RE: CHANGE ORDER PROPOSAL REQUEST #1 5/10/19

MARTIN LUTHER EVANGELICAL LUTHERAN CHURCH – RESPONSES FROM GARY BORROR – ARCH.

REV-1 5/23/19

proposed reflected ceilg plan at basemt  
1/8" scale

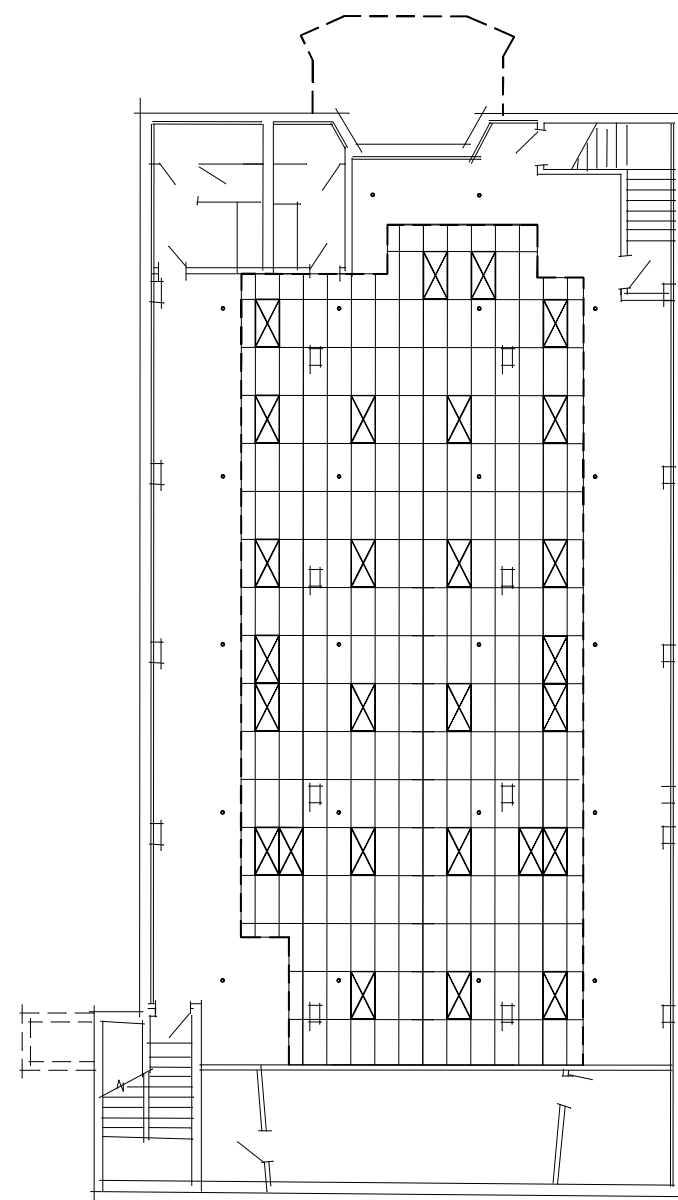
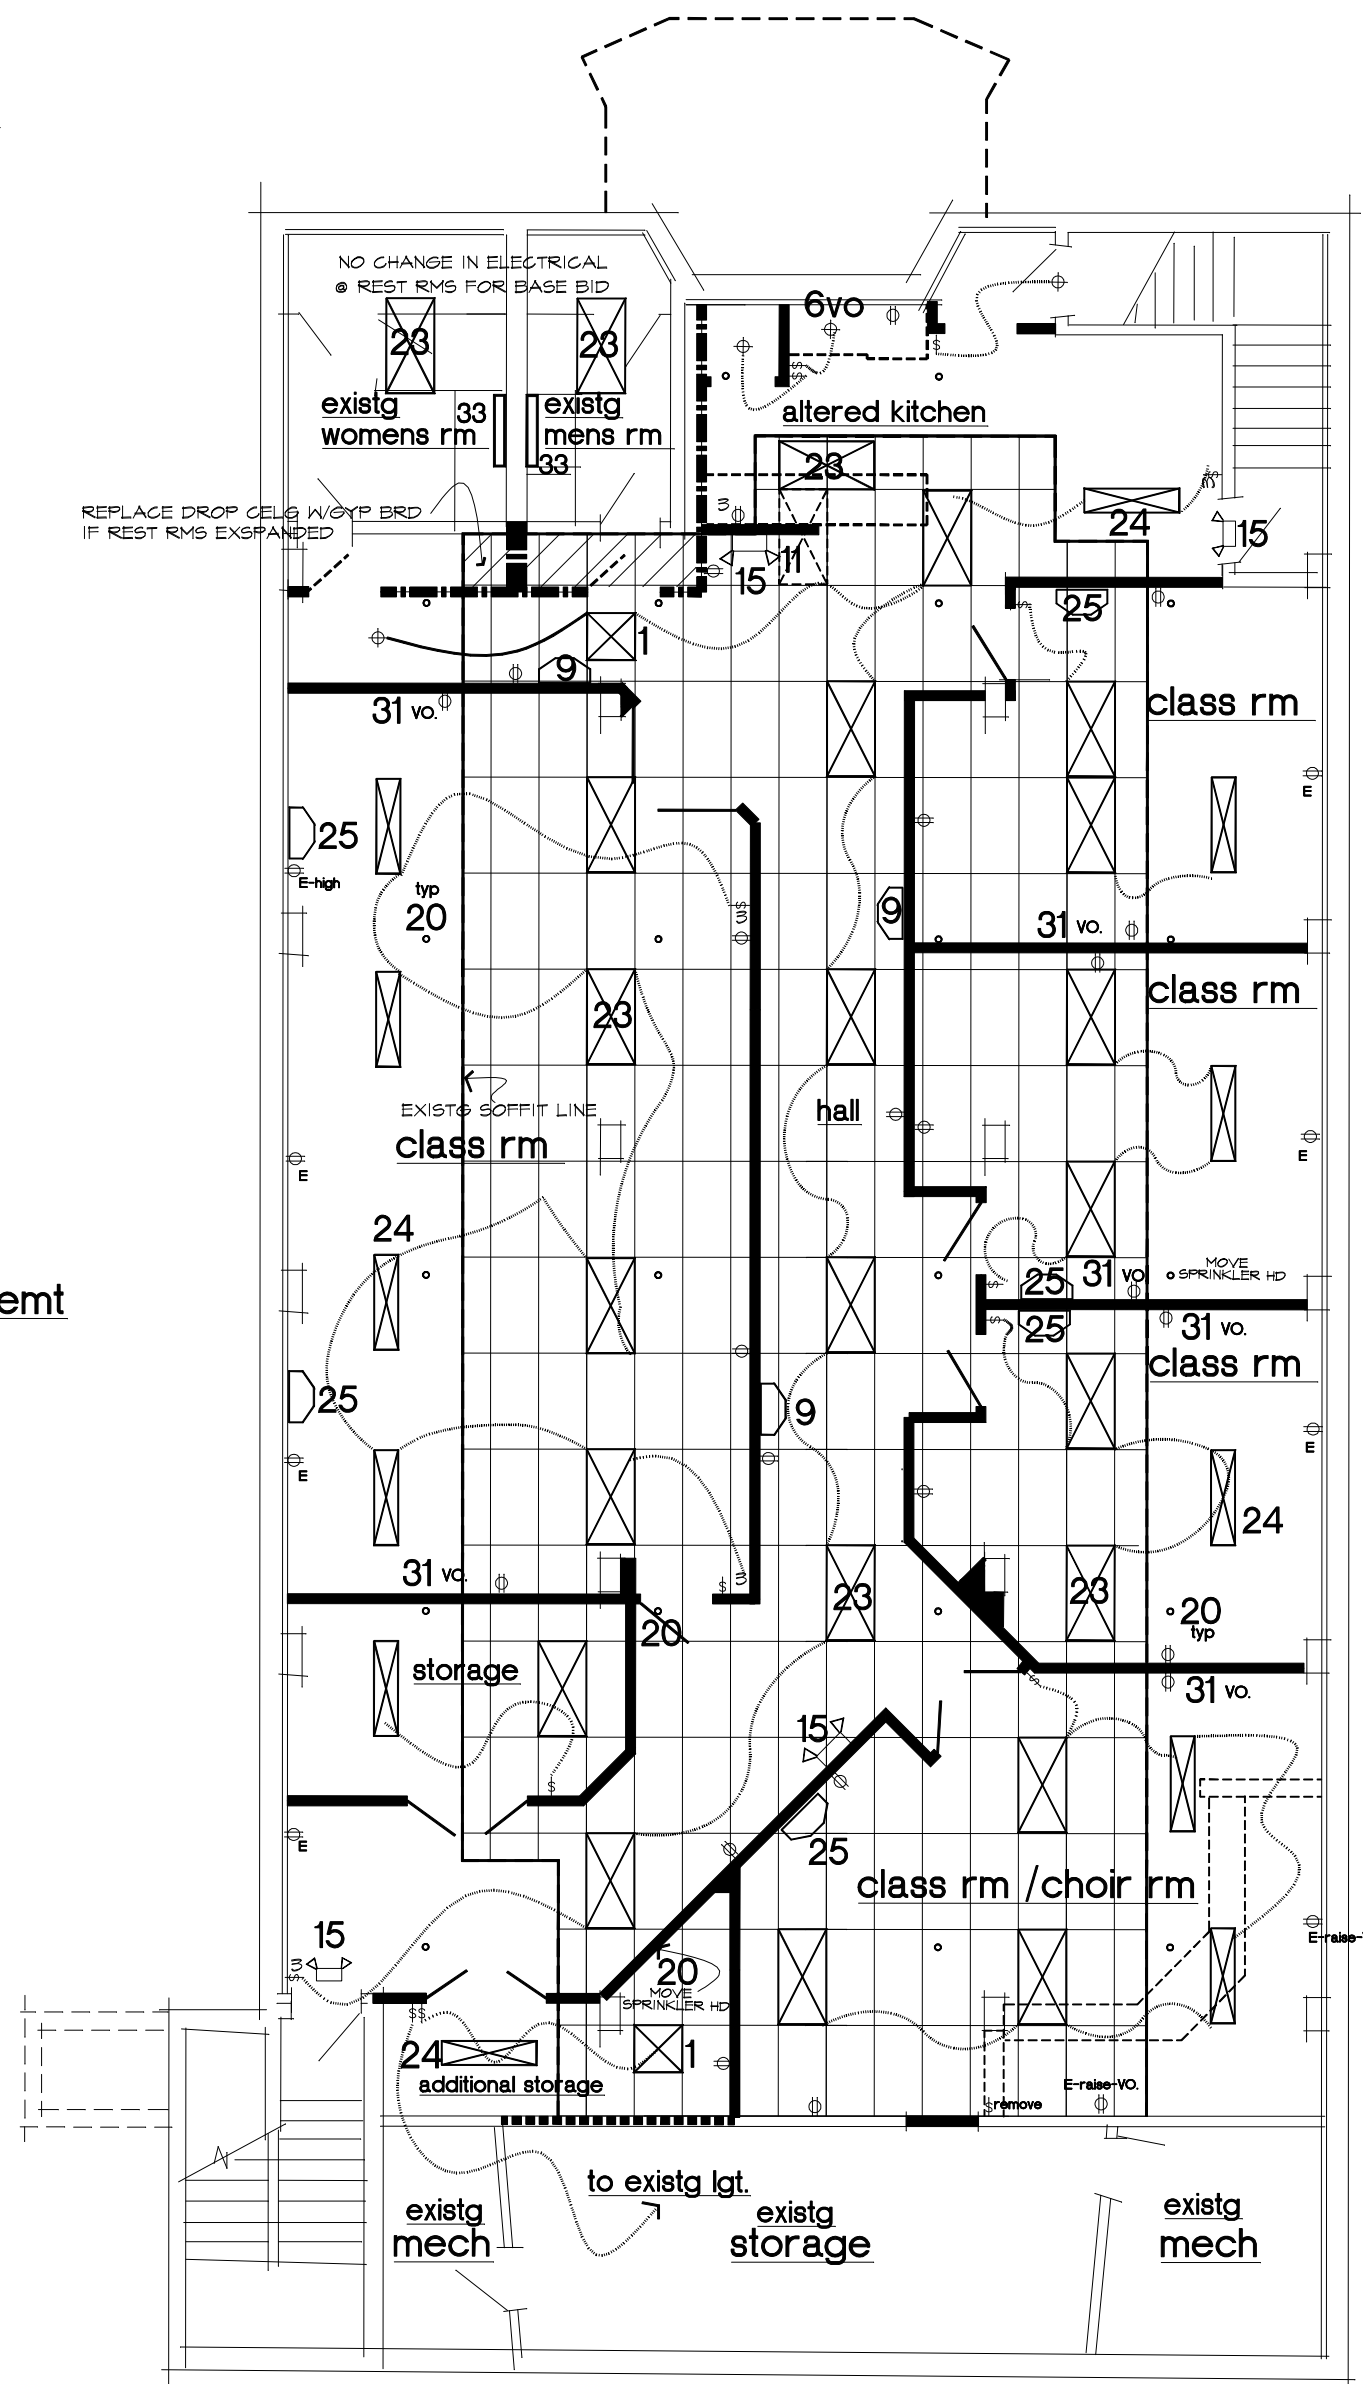
1. \* Lower Level Bathroom Lighting  
Add (1) 2x4 drop-in fixture in the center of the ceiling and a valence fixture over vanity  
--(See A1-3e, basement electrical plan and electrical keynotes #23 and #33, for changes)

2. \* Additional Emergency Lighting  
Replace emergency lighting fixtures for all locations not covered by drawings.  
--(See A1-3e, electrical keynotes #7 and #8 corrected to show REPLACE existing fixtures)

5. \* Fellowship Hall Ceiling Fans  
Remove ceiling fan near storage closets  
--(See A1-3e, garden level electrical plan, 4<sup>th</sup> ceiling fan removed from dwg)

1. Pendant lighting at Prep Kitchen – keep can lights  
--(no change to drawings)
2. \* Upstairs Bathrooms – replace recessed lights over vanities with a light over mirrors  
--(See A1-3e new restrooms and electrical keynote 33, can lights replaced with valence)

5. \* New power outlet at peak in Fellowship Hall where 4<sup>th</sup> ceiling fan to be removed  
--(See A1-3e fellowship hall drawing and electrical keynote 34, new power outlet for future projector – V.O.- added this change)

16. \* Patch at Narthex and Sanctuary Lighting Replacement  
--(See A1-3e keynote #27 replace light fixtures in Sanctuary Side Aisles & Narthex. See A1-3e drawing for Narthex and Sanctuary, recessed lights changed to just lights and note changed to "replace existing recessed light fixtures".)

- 7 REPLACE EXISTING EMERGENCY COMBO LIGHT WITH BATTERY BACK-UP FOR SAFE WORKING ORDER AND COMPLIANCE WITH APPLICABLE CODE REQUIREMENTS. TEST. REPAIR OR REPLACE AS NEEDED.

- 8 REPLACE EXISTING EMERGENCY COMBO LIGHT WITH BATTERY BACK-UP FOR SAFE WORKING ORDER AND COMPLIANCE WITH APPLICABLE CODE REQUIREMENTS. TEST. REPAIR OR REPLACE AS NEEDED.

- 31 VALENCE FIXTURE OVER VANITY
- 32 NEW POWER OUT FOR FUTURE PROJECTOR- VO
- 33 CHECK EXISTING EMERGENCY LIGHTING WITH BATTERY BACK-UP FOR SAFE WORKING ORDER AND COMPLIANCE WITH APPLICABLE CODE REQUIREMENTS. TEST. REPAIR OR REPLACE AS NEEDED.
